City of Santa Fe, New Mexico

Case #2015-46. River Trail Lofts, 2180 and 2184 West Alameda Rezoning with a Development Plan. Sommer Karnes & Associates, agent for Alameda Lofts Investments, LLC requests rezoning 4.25 acres from R-5 (Residential, 5 dwelling units per acre) to R-7 (Residential, 7 dwelling units per acre). The application includes a Development Plan for 32 dwelling units. (Donna Wynant, Case Manager)

City of Santa Fe
Planning Commission
Findings of Fact and Conclusions of Law

River Trail Lofts, 2180 & 2184 West Alameda Rezoning to R-7
River Trail Lofts, 2180 & 2184 West Alameda Development Plan

Zoning Map

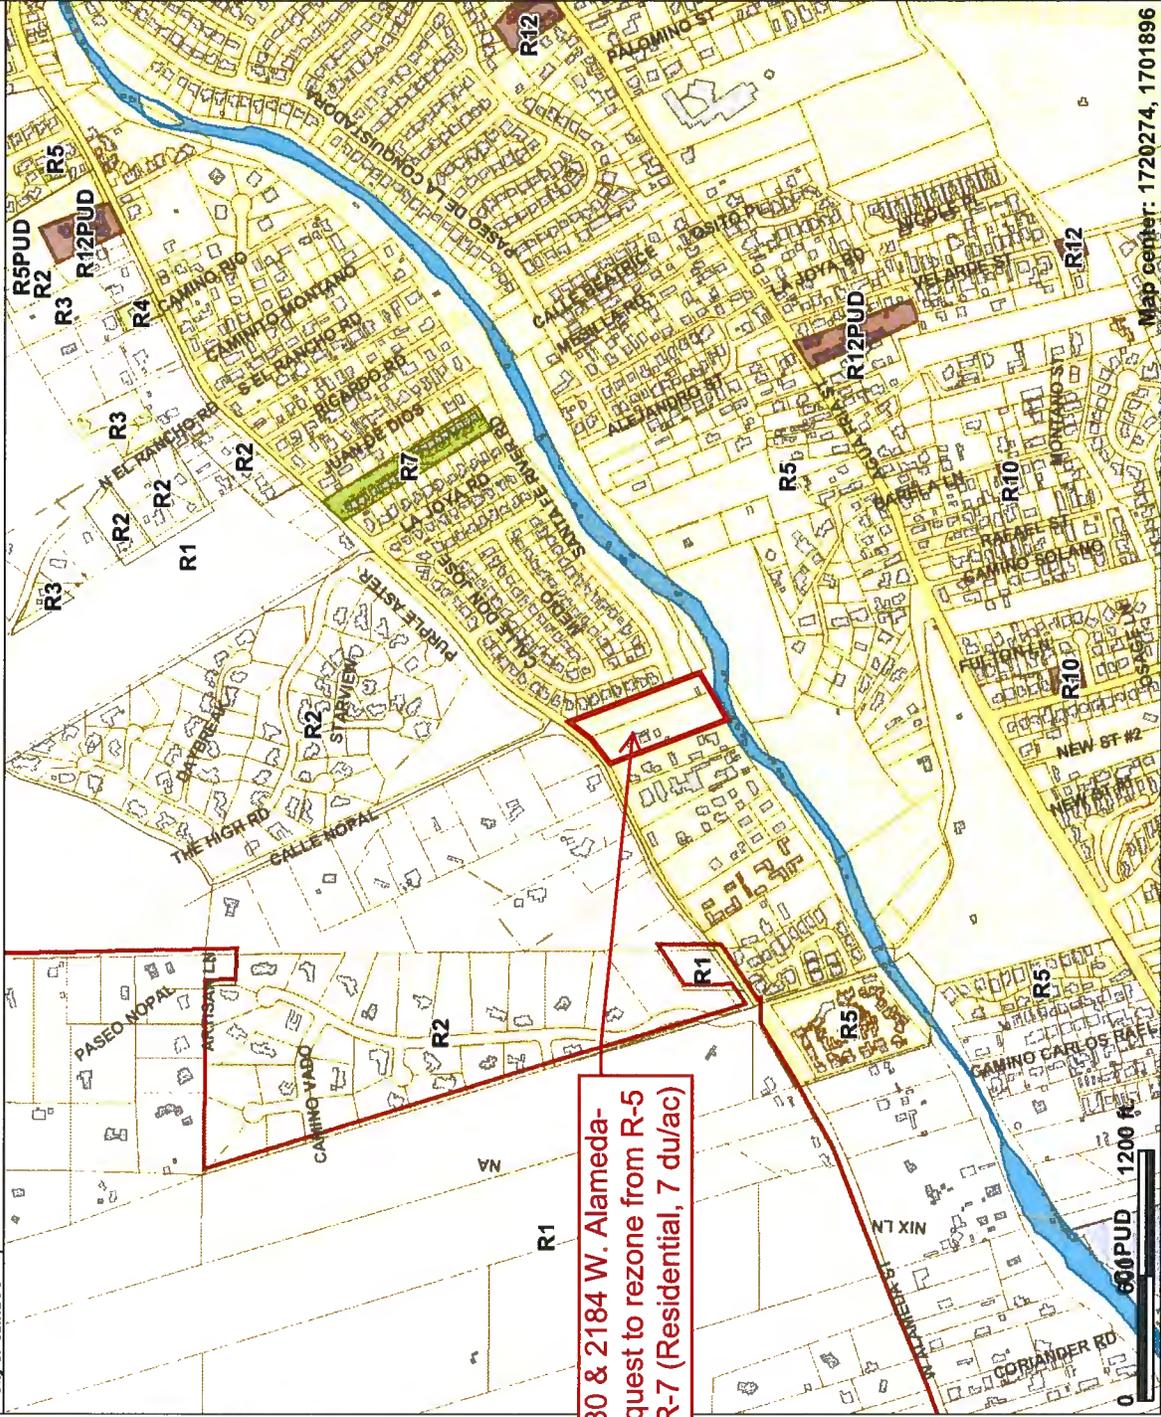
Commissioner Padilla said there has been discussion that the density proposed is not appropriate for the area. He said Rio-Vista Subdivision is shown on the zoning map as an R-7, and asked staff to clarify if the zoning is R-5 or R-7.

Mr. Smith said, "I believe there is confusion because the exhibit in the packet shows R-7 in the green tinted parcel. That is not the Rio Vista Subdivision. That is the parcel that is east of the Rio Vista Subdivision. The Rio Vista Subdivision is zoned R-5. If I might note for the record, there has been considerable discussion about the calculation of density in the R-5 and in the R-7. Let me just clarify for the record that the proper calculation is the maximum density of 24 units under R-5 and 32 units under R-7. In each case, allowing for the maximum density bonus for affordable housing units."
